Batemans Bay Bridge replacement project

Community consultation report for the Urban
Design and Landscape Plan

Transport for NSW | September 2021

New Floating Pontoon

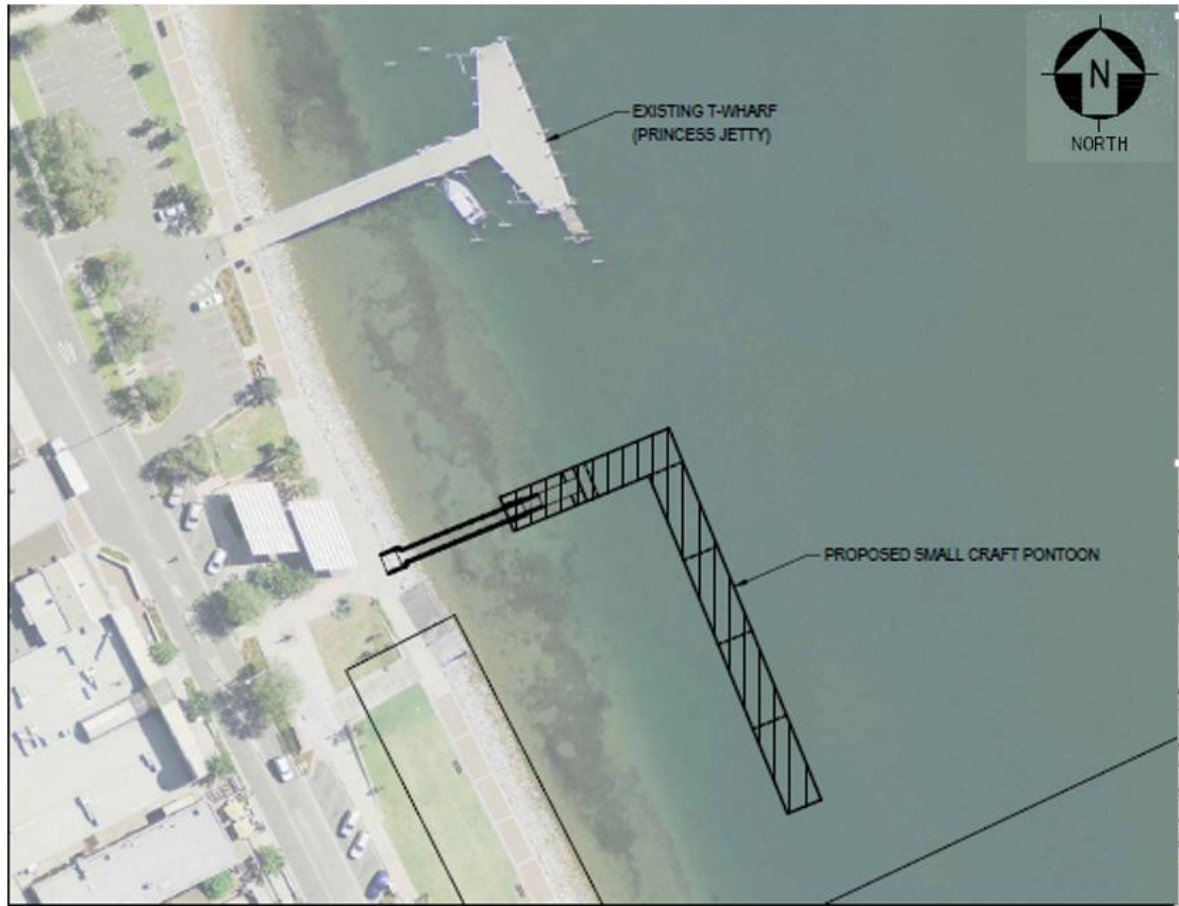
Submission reference number	Issue/s	Response
3.4.1 3.4.11	A request was received to ensure access for a diverse	The design for the new floating pontoon includes a free board height of 350mm to 450mm which will allow access for a diverse range of users.

3.4.8	A request was received to install pylons inside the new pontoons for the safety of people accessing or exiting watercraft tied to the wharf.	Where feasible, edges of the new floating pontoon will be free from piles or the piles will be set flush alongside the pontoon to provide unobstructed access for vessels to berth while also ensuring safe access between the pontoon and vessels.

3.4.9	A question was received regarding which entity will be responsible for maintenance of the structure due to damage by boats.	The pontoon will be maintained by Transport for NSW. The pontoon has been designed to consider mooring loads, fenders will be provided to minimise impact damage to the pontoon and vessels.

3.4.15	A question was received about the need for a davit system and whether people would require special implements to use the facility.	The design for the new floating pontoon includes provision for the future or temporary installation of a davit system to assist people with a disability to access vessels.

3.4.20	A submission was received which outlined the technical and safety requirements for cruise ship tenders, and requested further detail on the new Batemans Bay wharf facility dimensions and inclusions. The submission advised seamless movement from boat tender to pontoons would allow passengers	<p>The new floating pontoon will be designed to a high quality and to meet current Australian safety standards.</p> <p>Where feasible, edges of the new floating pontoon will be free from piles or the piles will be set flush alongside the pontoon to provide unobstructed access for vessels to berth while also ensuring safe access between the pontoon and vessels.</p> <p>The 6m width of the pontoon allows for temporary ramps and steps to provide assisted access to taller vessels.</p> <p>To cater for a variety of vessel types and sizes, the new pontoon will incorporate a range of vessel securing options which may include cleats, bollards and piles.</p>

Southern Foreshore Fishing & Viewing Platform

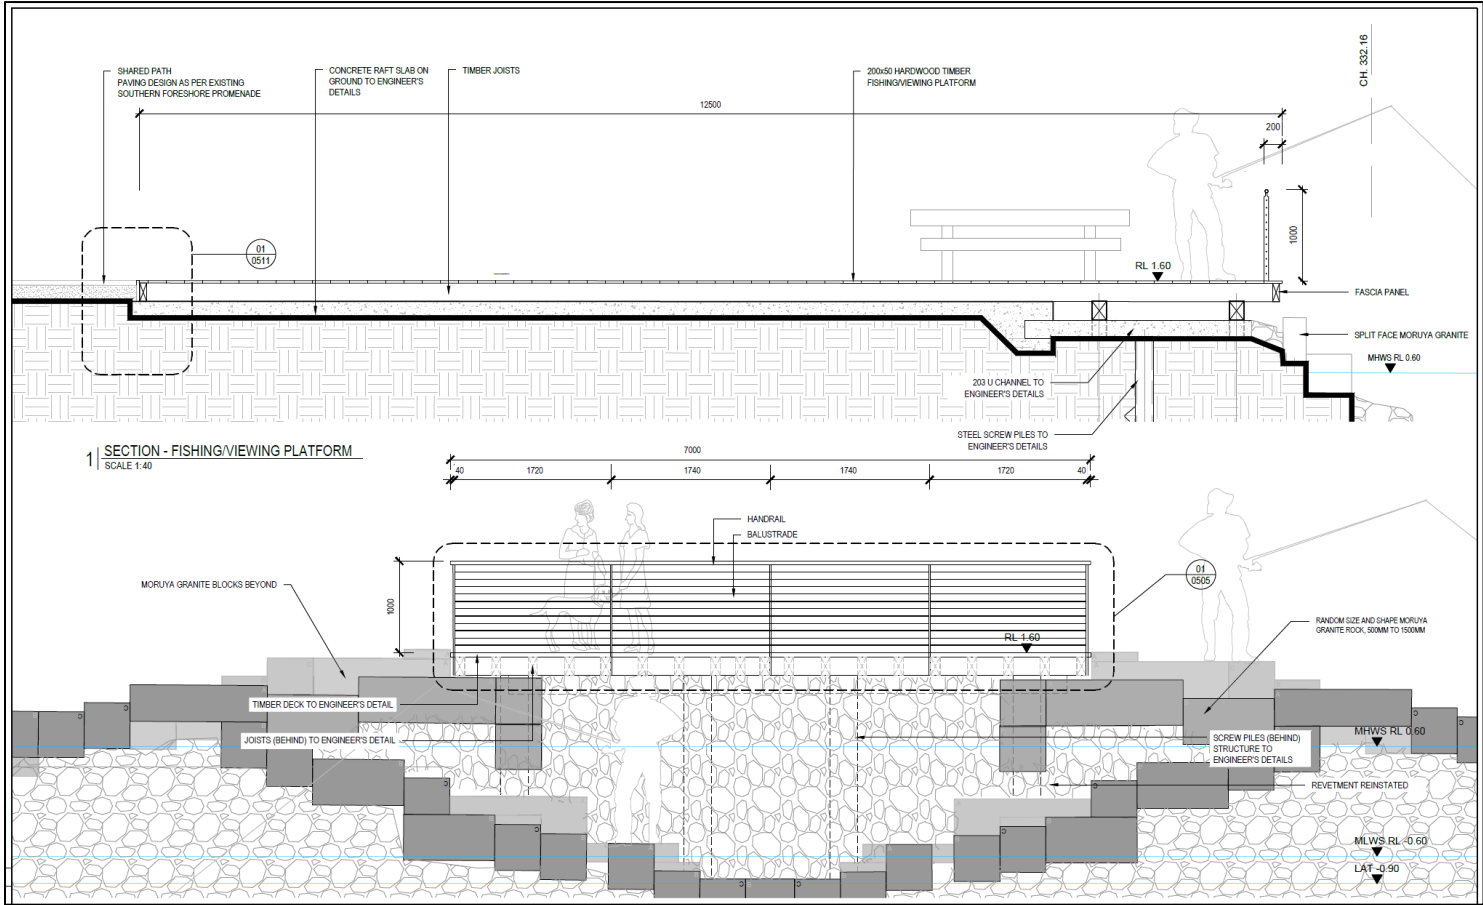
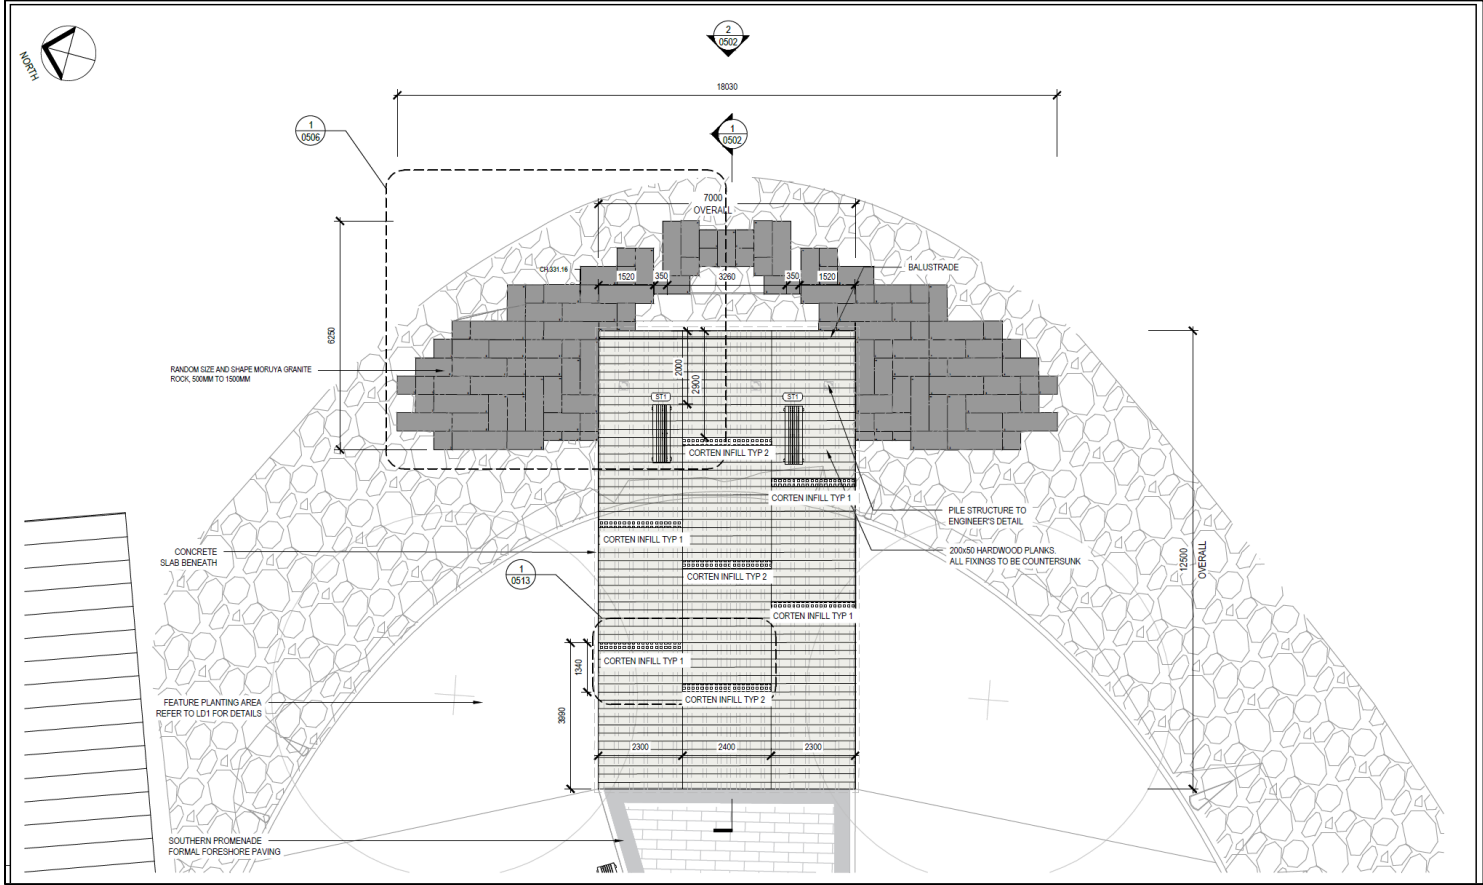
Submission reference number	Issue/s	Response
3.5.1 3.5.6 3.5.7 3.5.8	Four submissions were received that requested the fishing and viewing platform be extended further over the Clyde River. Additionally, one of the requests was for the granite steps to be extended.	The foreshore design has been improved by installing additional granite blocks adjacent the viewing and fishing platform to provide access to the water level at Lowest Astronomical Tide (LAT).

3.5.10	A request was received to include a metal cover over the viewing and fishing platform, at the same height as the old bridge deck to provide an understanding of the height, scale and trajectory of the old bridge. This could include roof supports with open sides, made from the old bridge beams in a lattice design similar to the bottom of the old bridge.	<p>Including a roof or pergola over the platform was considered in the design. However, it was determined that a roof would introduce undesirable elements including a roosting area for pelicans, interference with fishing, and could result in a foreshore that feels cluttered and therefore will not be included in the final design.</p> <p>A separate sculpture will be installed to honour the existing bridge.</p>
